Fashion & Styles

Latitude: [31.502287], longitude: [73.10175]
Date of inspection: 12-Mar-2026

Fire Safety Inspection Report

Pakistan Accord Initial Safety Inspection Report

Figure 1.4. Egress Layout of Building 1.

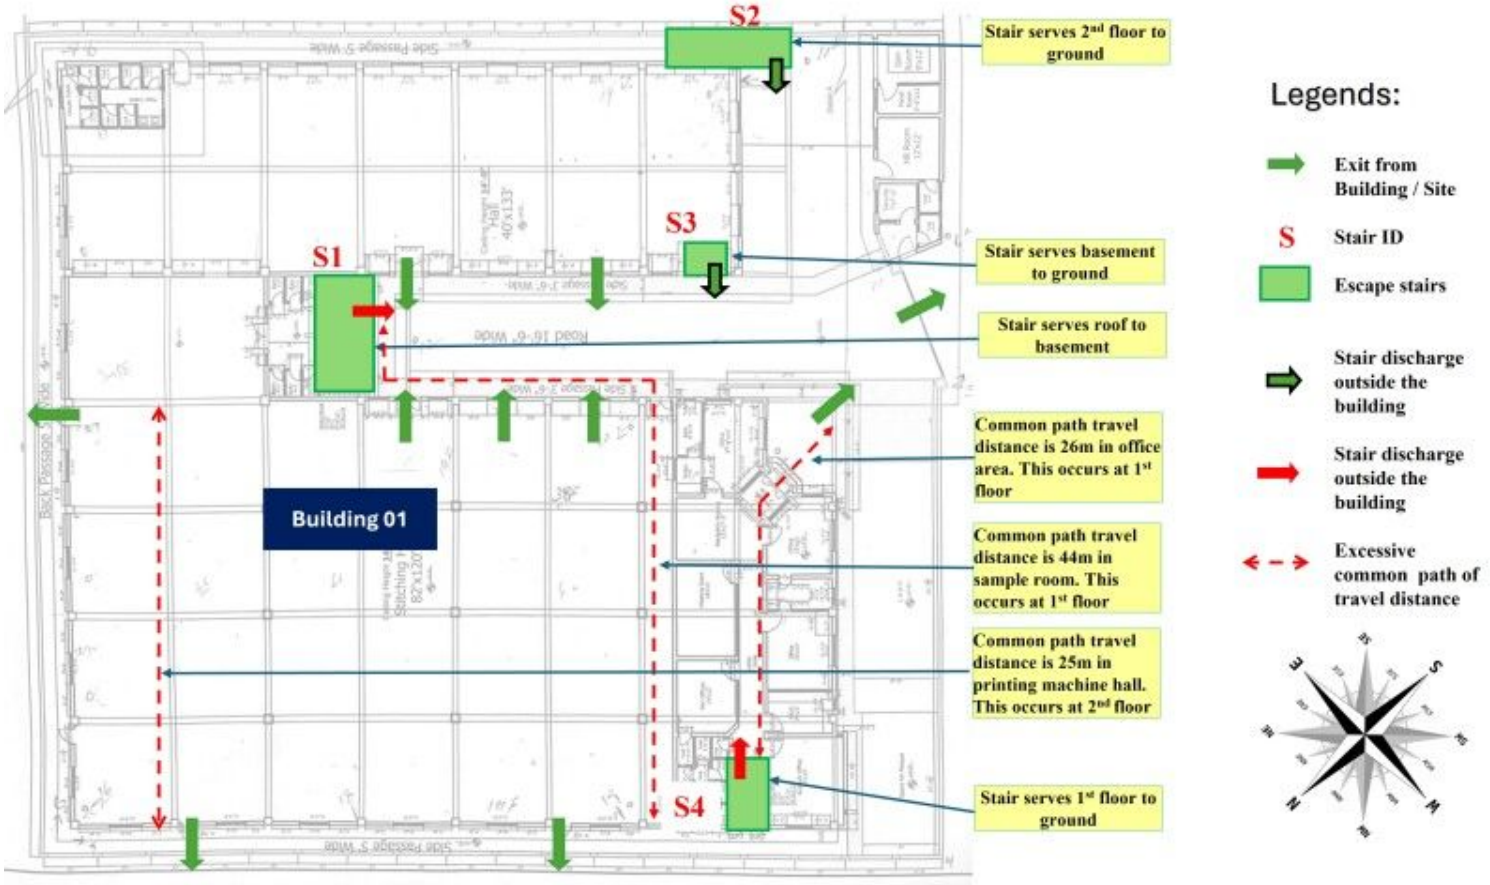
The number of exits is insufficient at offices(1st floor) Building 1. Excessive common path of 25m, 26m and 44m were found at printing machine hall (2nd floor), office area and sample room (1st floor) of Building 1.

Figure 2.17 - Missing exit signs at entry into stair S4 from 1st floor of Building 1.

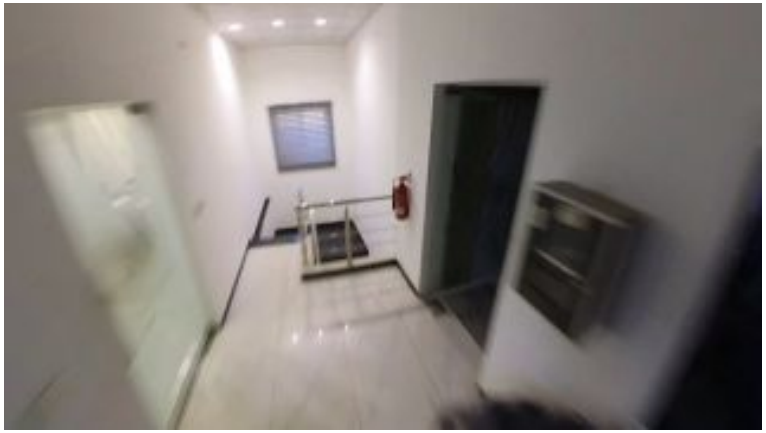
The following deficiencies have been observed on site, including (list not exhaustive):
- Missing exit signs at entry into stair S4 from 1st floor.
- Missing exit signs in production areas at printing hall (2nd floor) Building 1.
- Missing exit signs in office area (ground floor) at Building 1.
- Exit signs are not clear / misleading such as misleading emergency exit sign at cutting area (2nd floor) as it leads towards the closed door installed at balcony.
-Electrically powered exit signs are not a tested and listed system.

Timeline	Remediation Plan
Immediate CAP-0076316	Remove misleading directional escape signs.
Medium Term CAP-0076317	Rectify and/or provide exit signage so access to exits is marked by approved, readily visible signs from all areas of the floor and clearly visible at exits, to comply with Pakistan Accord Standard and BCP 10.15.1, 10.15.2 and 10.15.3
Longer Term CAP-0076318	Ensure that all exit signage is checked periodically and in good working condition.
